CHANDIGARH HOUSING BOARD

STANDARD DESIGN OF G.H.S. IN WEST OF SECTOR - 38 CHANDIGARH, (U.T.) H.I.G. (UPPER)

GROUND FLOOR PLAN (Location of lift)

STANDARD DESIGN OF G.H.S. IN WEST OF SECTOR - 38 CHANDIGARH. (U.T.) H.I.G. (UPPER)
 TERRACE FLOOR PLAN (Location of lift)

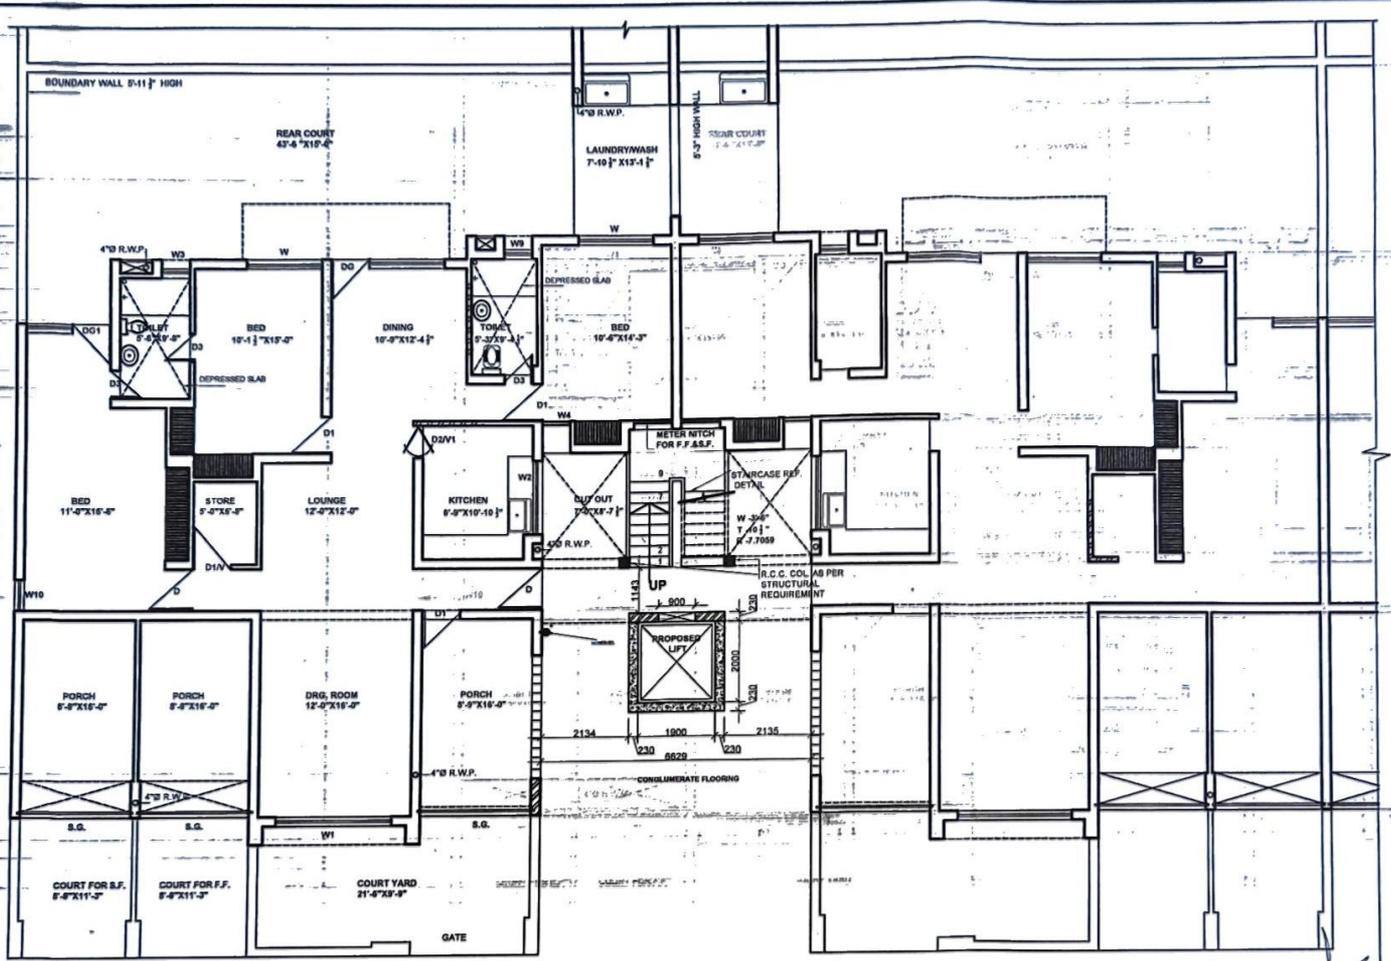
NOTE:
 This drawing supersedes drg. no. 30 job no. 164 approved by PAC (L) on 29.07.2024. The car and the shaft size of the lift has been revised to 1100mm x 1300mm (car size) and 1900mm x 2000mm (minimum) respectively with clear door opening of 900mm, as was decided in the meeting PAC (L) held on 26.08.2025, the decision of which was circulated vide memo no. 2273893 dated 26.08.2025. The conditions shall remain the same as approved earlier.

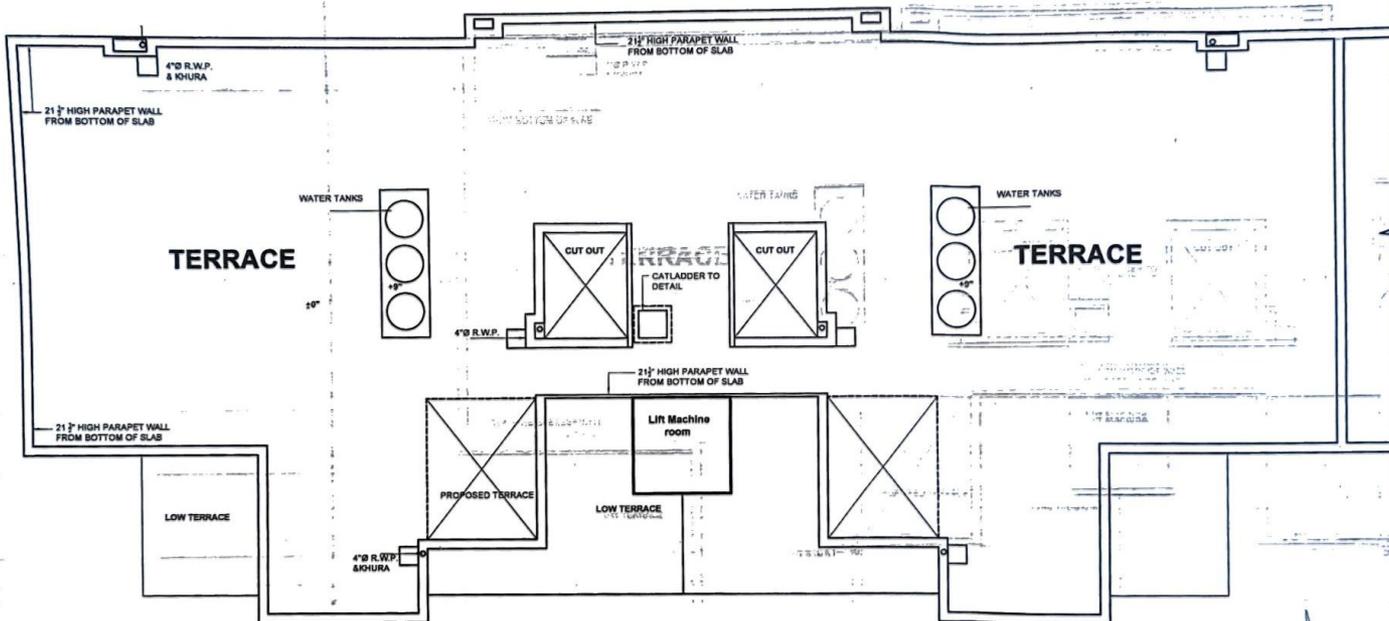
NOTE:
 This drawing supersedes drg. no. 33 job no. 164 approved by PAC (L) on 29.07.2024. The car and the shaft size of the lift has been revised to 1100mm x 1300mm (car size) and 1900mm x 2000mm (minimum) respectively with clear door opening of 900mm, as was decided in the meeting PAC (L) held on 25.08.2025, the decision of which was circulated vide memo no. 2273893 dated 26.08.2025. The conditions shall remain the same as approved earlier.
